PLANNING COMMISSION
MEETING AGENDA
REGULAR MEETING

Special Use Review
For
City of Troy, Michigan

Applicant:	Clawson Troy Elks
Project Name:	Clawson Troy Elks Lodge
Plan Date:	September 10, 2010
Location:	2549 Elliott Drive
Zoning:	M-1, Light Industrial District
Action Requested:	Preliminary Site Plan Approval, Special Use Approval
Required Information:	Deficiencies noted

Applicant:	Robert Waldron on behalf of Martha Waldron
Project Name:	Pro Car Wash West
Plan Date:	September 14, 2010
Location:	3785 Rochester Road
Zoning:	H-S, Highway Service
Action Requested:	Preliminary Site Plan Approval
Required Information:	Deficiencies noted

DRAWING NUMBER:
P-3

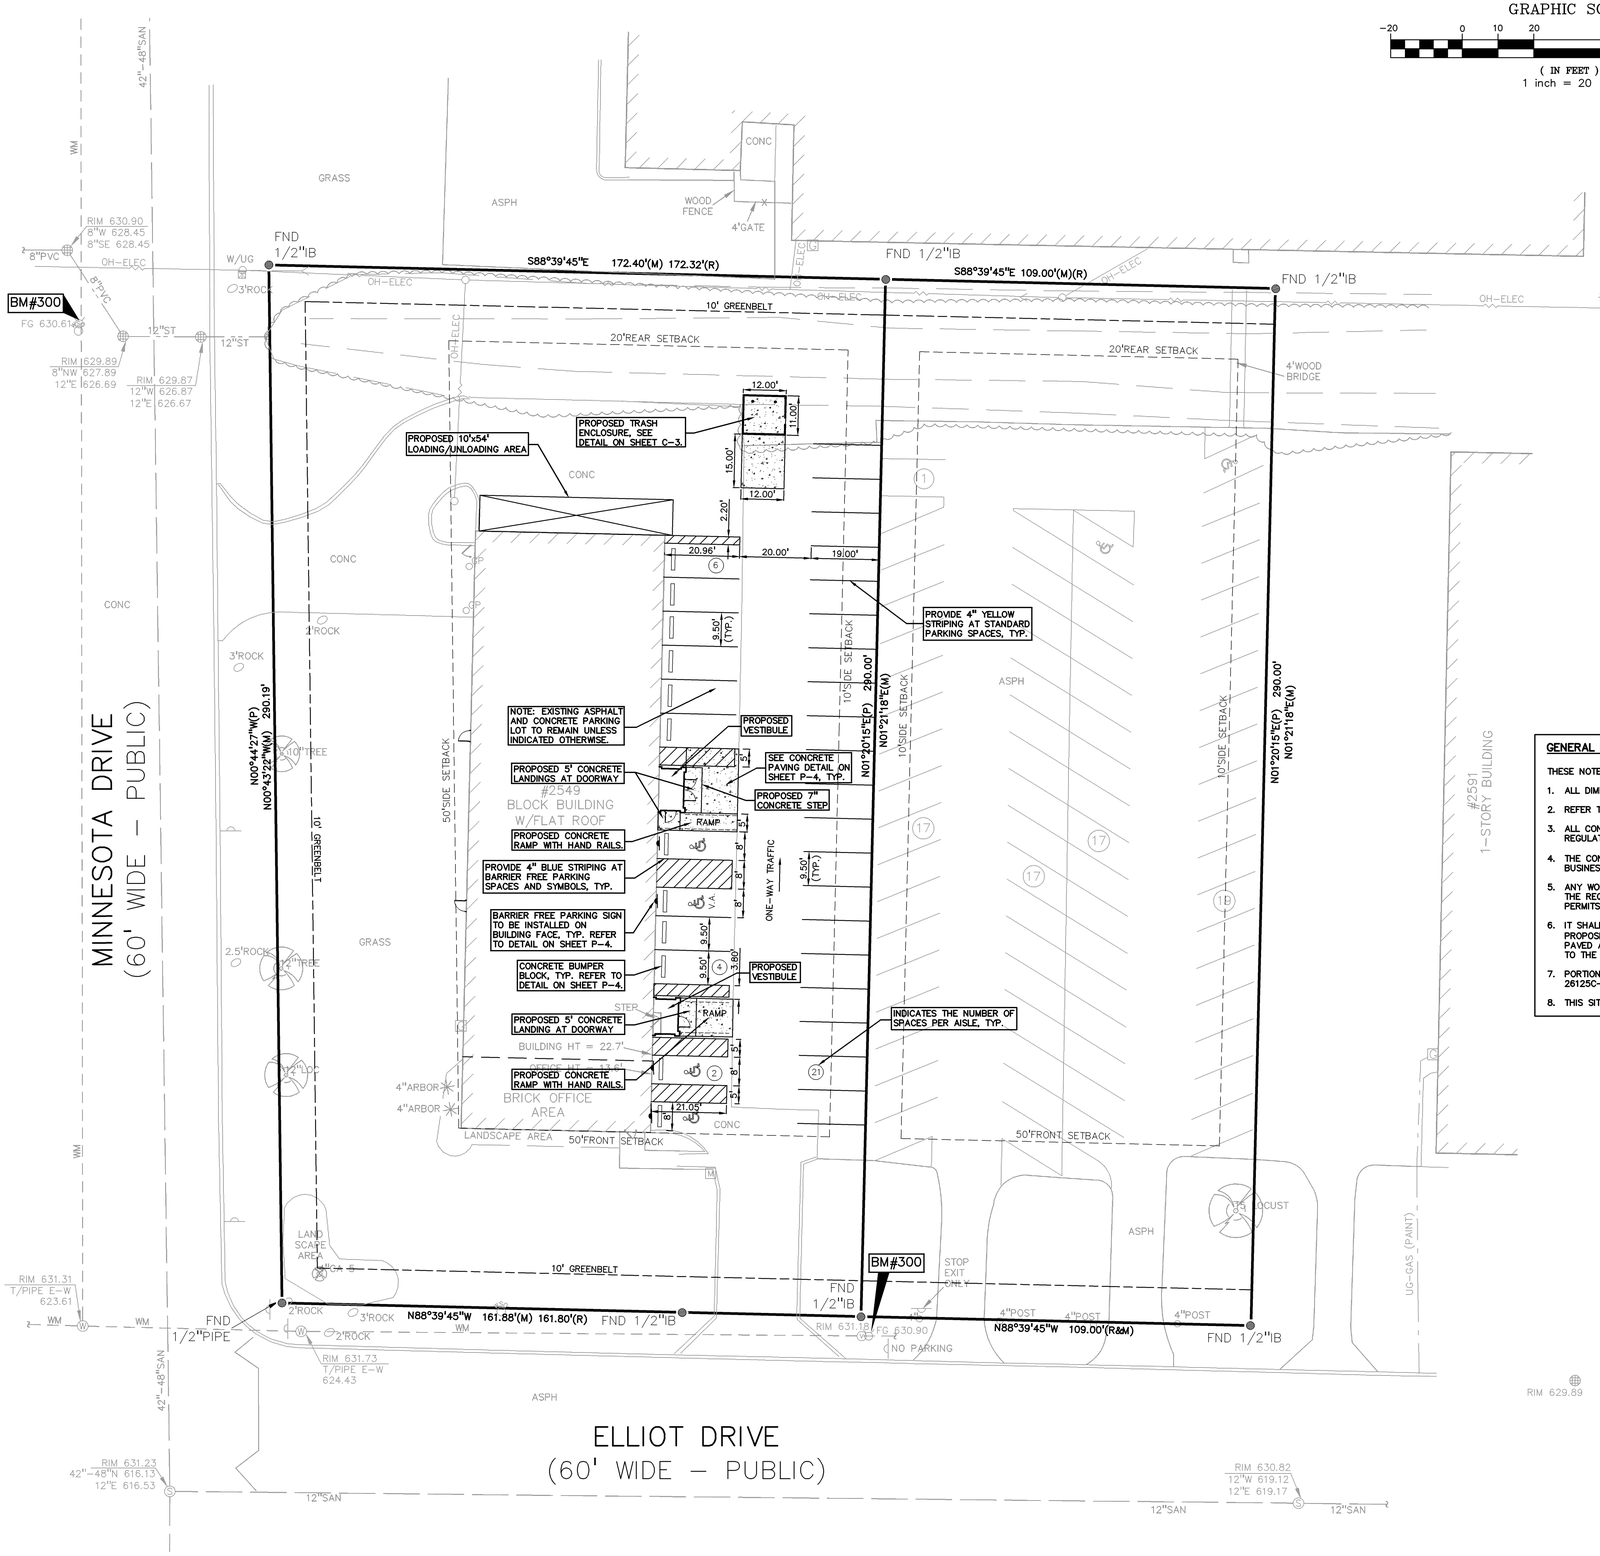
The parking calculations provided on sheet P-3 were used to make these parking determinations. The floor plan, provided by another designer, contradicts these square footage and occupancy requirements slightly. A final, accurate, consistent set of calculations will be required for final site plan approval.

The site pan is deficient by 22 parking spaces. However, the industrial use to the east has a significant parking area, and will likely have different peak parking demand hours from the proposed use. The applicant has indicated on sheet P-3 that an agreement has been reached with the adjacent owner to allow overflow parking to meet demand during peak times, in the rare occasion when the entire facility would be used to full capacity. An easement will be necessary to guarantee this shared parking arrangement. While we support this approach, the applicant must provide legal documentation that such an agreement for an easement is in place, in a form acceptable to the City Attorney, prior to final site plan approval.

Items to be Addressed**:** *1.) Provide final, accurate, consistent occupancy and square footage calculations. 2.) Secure a shared parking easement and provide documentation to the City Attorney.*

PRELIMINARY LANDSCAPE PLAN
CLAWSON-TROY ELKS LODGE #2169
PART OF THE SE 1/4 OF SECTION 36, T.2N., R.11E.
CITY OF TROY, OAKLAND COUNTY, MICHIGAN

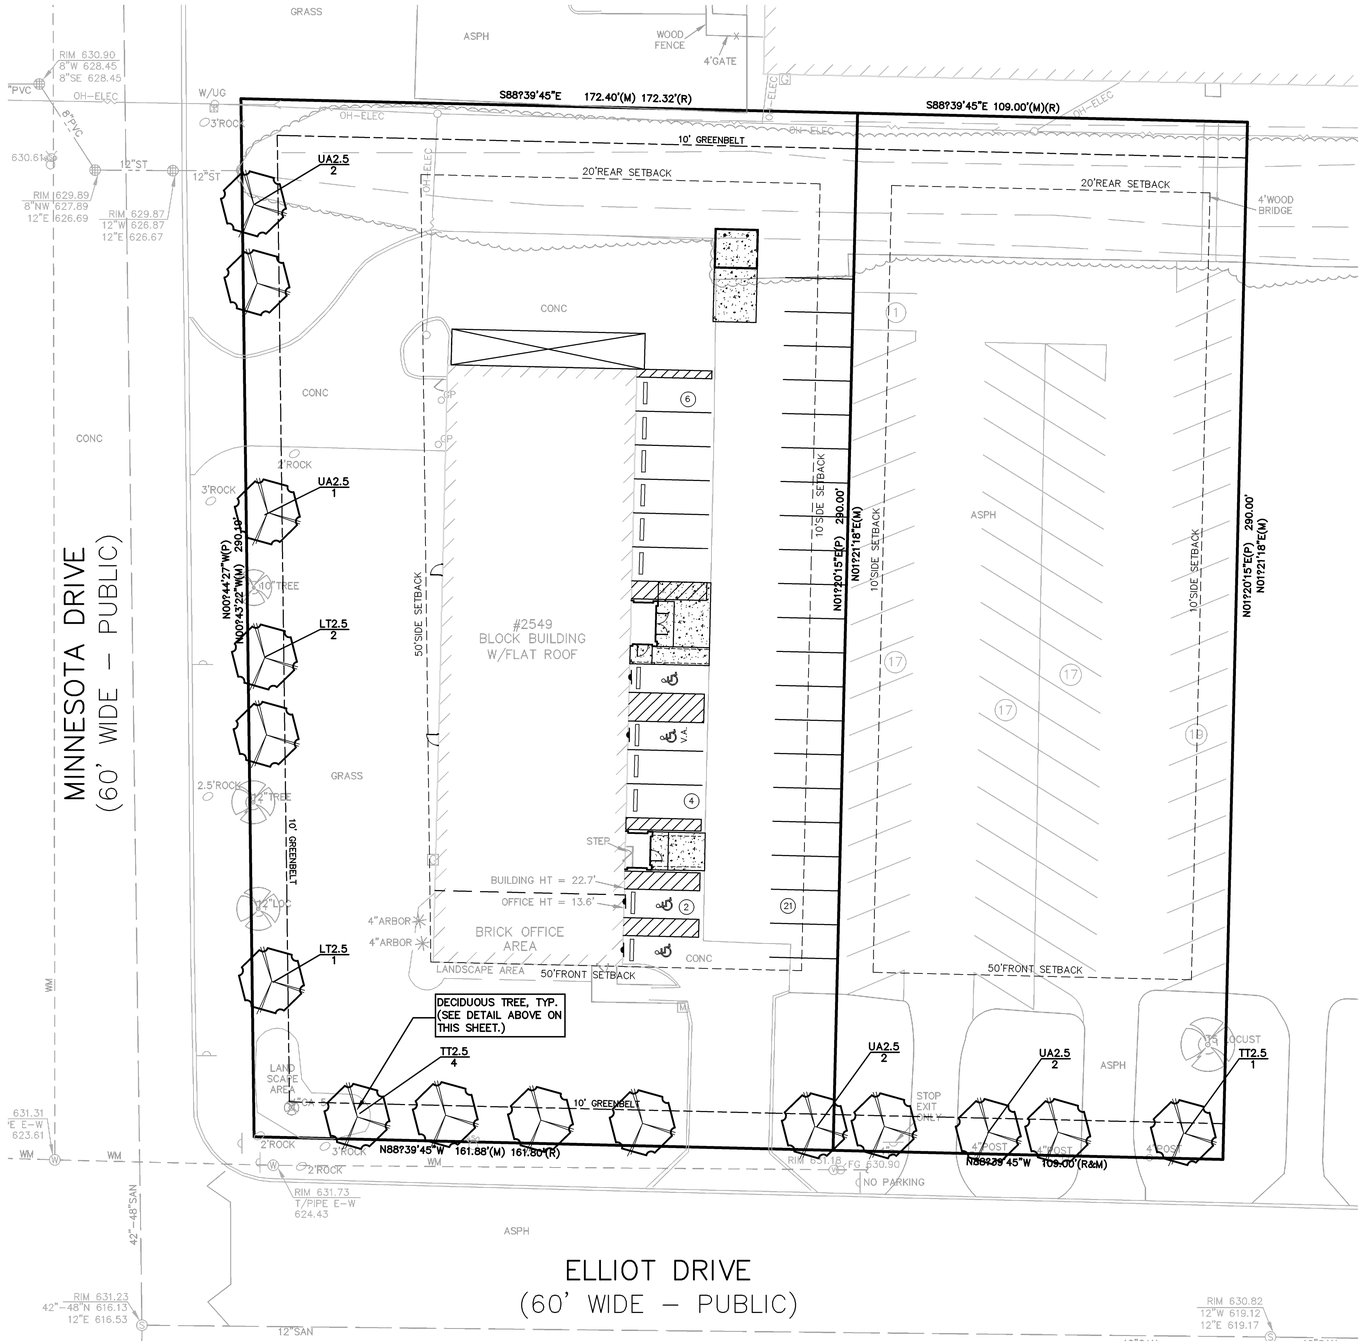
A landscape plan has been submitted as part of this application. In the M-1 District, street trees are required at a rate of one three for every 30 linear feet of frontage along both streets. The subject site has 560 feet of frontage requiring 19 street trees. The site has 4 existing trees, and the applicant has shown in the landscape plan that an additional 15 trees will be added to the site. The site also maintains the required 10-foot greenbelt along both frontages, and has 36% open space, mostly in the two front yards, exceeding ordinance requirements.

Landscape / Tree Preservation Plan

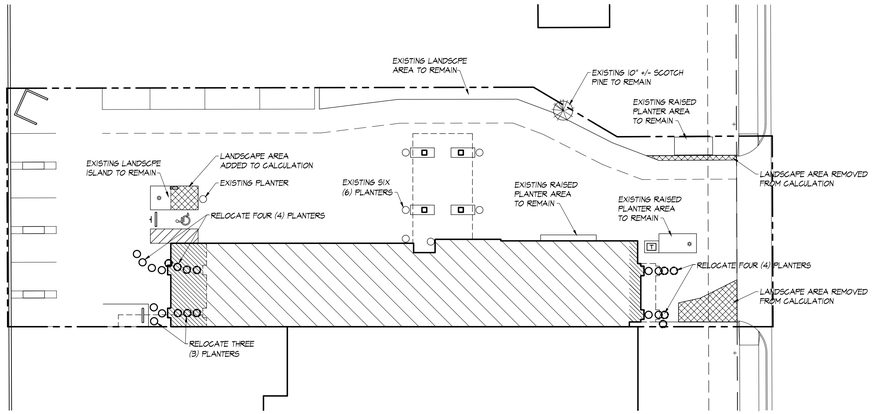
A landscape plan has been provided identifying how Ordinance requirements are being met. The site does currently have required frontage trees, and the applicant has relocated several existing planters, reducing waste and the need for new plants. The revised site plan preserves only one tree, which does not qualify as a frontage tree. The required frontage trees must be provided, although we do recognize the limited area in which trees could be located near the right-of-way. This should be discussed with the Planning Commission.

2,918 square feet, but the plan only allocates 1,388 square feet. Thus, the site plan is deficient by 1,530 square feet of landscaped area.

Items to be addressed*: 1.) Provide frontage trees. 2.) Obtain a variance from the Zoning Board of Appeals for landscaping deficiencies.*

Architectural Site Plan

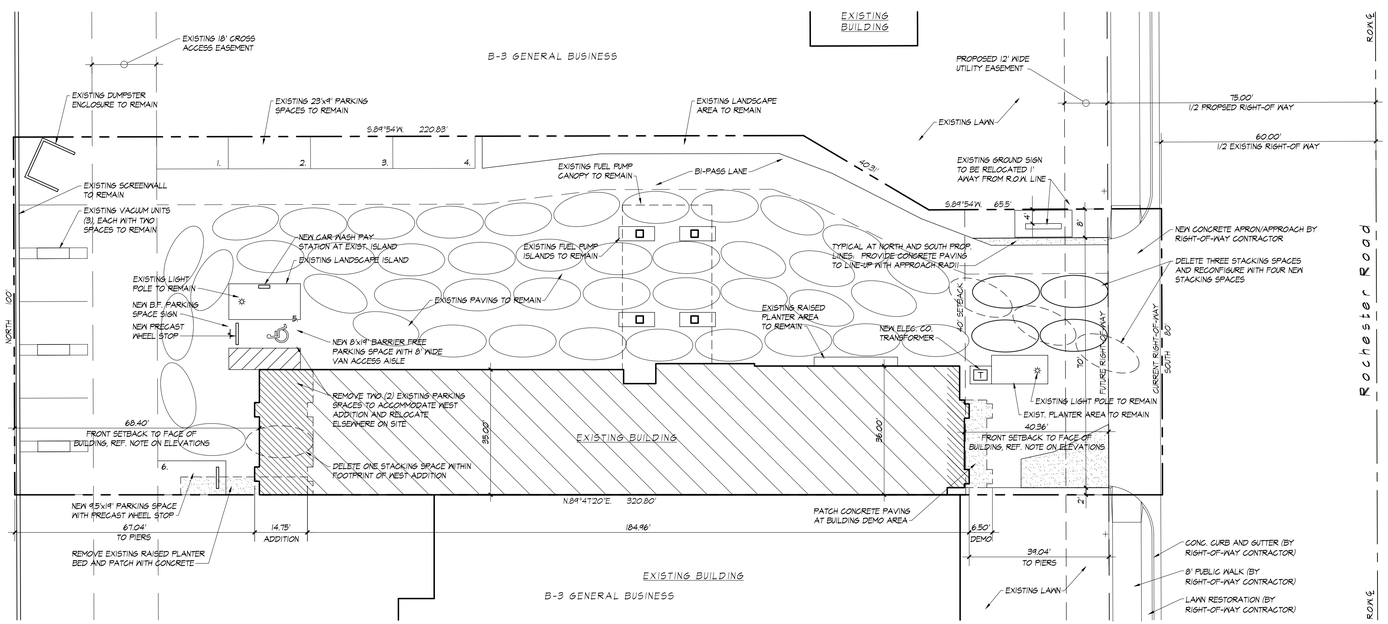
The proposed building addition encroaches upon the required rear yard setback by 6.6 feet. This will have to be addressed through altering the site plan or obtaining a variance from the Zoning Board of Appeals.

The increased automatic car wash square footage results in an increase in required stacking spaces. The site plan proposes some stacking spaces which clearly conflict with the fuel pump parking, however. We calculate that the site plan only provides 33 spaces that can truly be considered stacking spaces for the car wash. The Zoning Ordinance requires stacking parking calculations to be based upon feet of wash line. Automobile wash stacking spaces must be provided at a rate of five spaces per 20 feet of wash line, or in this case, 50 spaces. Therefore, the site is deficient 15 automobile wash stacking spaces. However, 47 spaces are shown on the site plan, and were there to be no vehicles at the pump stations; it is conceivable that all 47 spaces shown could be occupied. Of course, access not only to the refueling stations, but also to the access and exit lanes would also be restricted if all 47 spaces were occupied.

Two (2) parking spots are blocked by the car wash queue. This may not be a problem which can be solved on this restricted site. Also, this condition currently exists in many car wash facilities. The space near the car wash entrance, for instance, will likely be used by staff, and it is unlikely that such demand will exist in the site that the barrier-free space, which is located so as to provide access to the main building, will be blocked.
